RE: NPDES Permit AR0000752, AFIN 70-00040  
**Quarterly reports required by CAO LIS 98-119**

RE: Compliance Inspection

Re: El Dorado Chemical Company  
Response to Compliance Inspection 9-12-08; NPDES Permit No. AR0000752

<b>Photo #</b>	1	<b>Of</b>	5	<b>Date:</b>	12 Sept 2008	<b>Time:</b>	15:38
----------------	---	-----------	---	--------------	--------------	--------------	-------

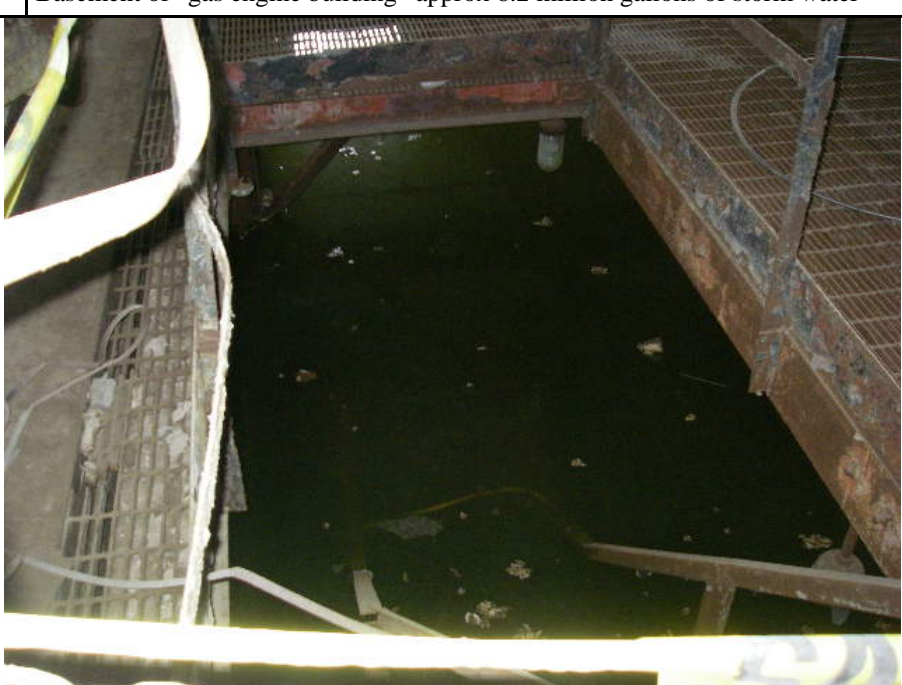
<b>Description:</b>	Inside the "gas engine building" used only as a warehouse						
---------------------	---	--	--	--	--	--	--

<b>Description:</b>	Basement of "gas engine building" approx 6.2 million gallons of storm water						
---------------------	---	--	--	--	--	--	--

<b>Photo #</b>	5	<b>Of</b>	5	<b>Date:</b>	12 Sept 2008	<b>Time:</b>	15:27
----------------	---	-----------	---	--------------	--------------	--------------	-------

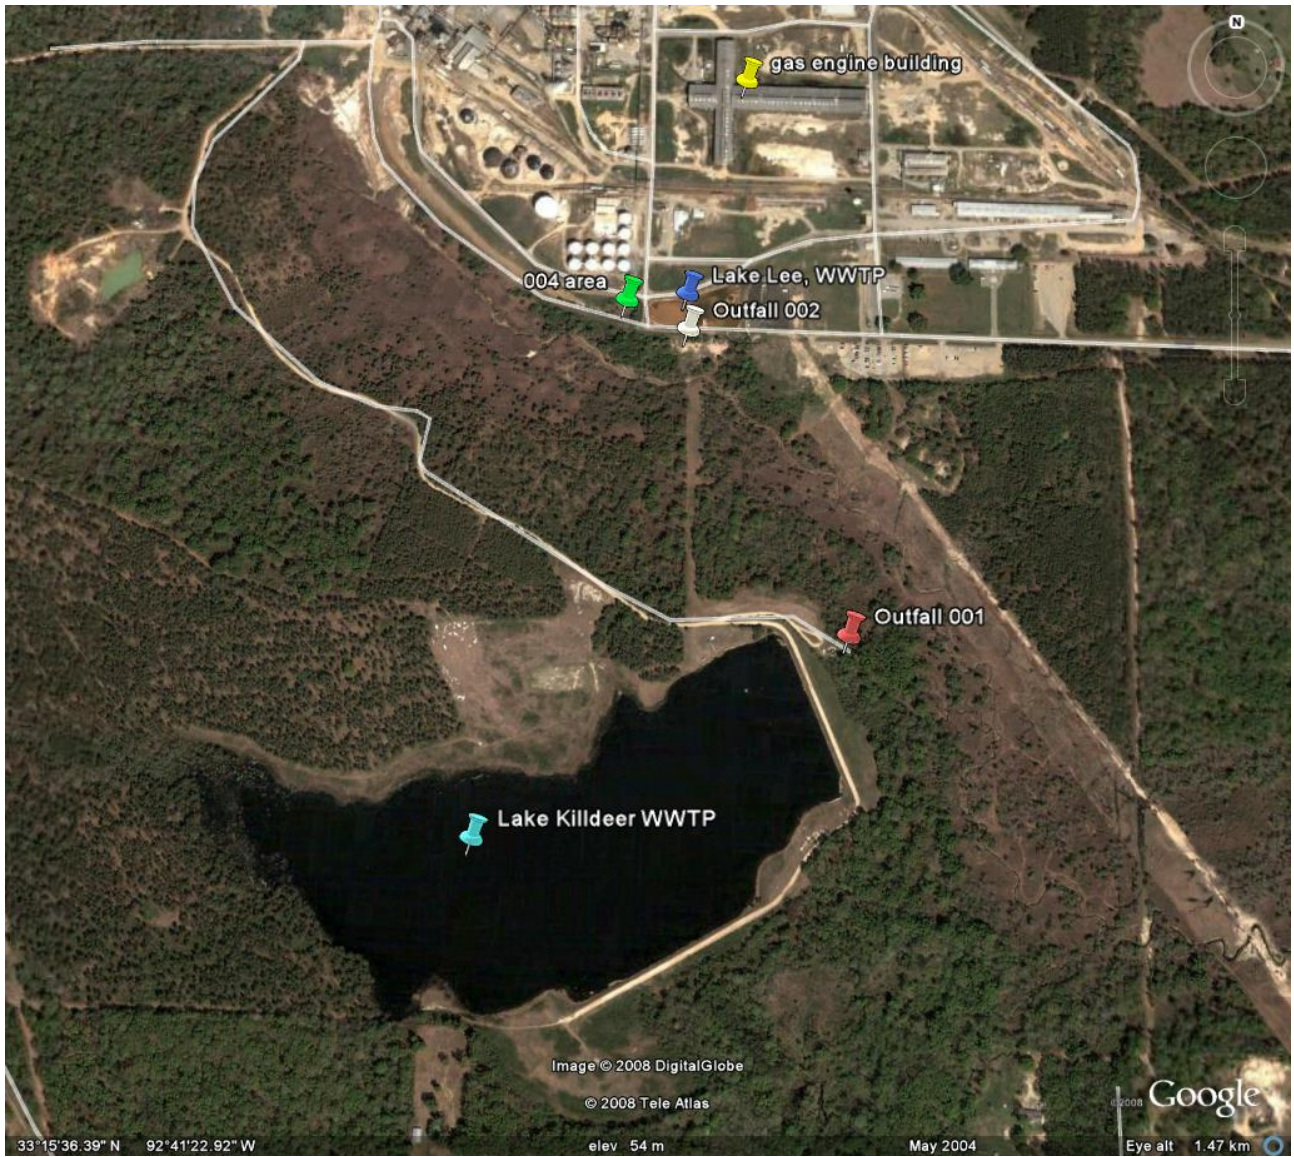
<b>Description:</b>	This is the location of the overflows from area 004. (These overflows were reported)
---------------------	--
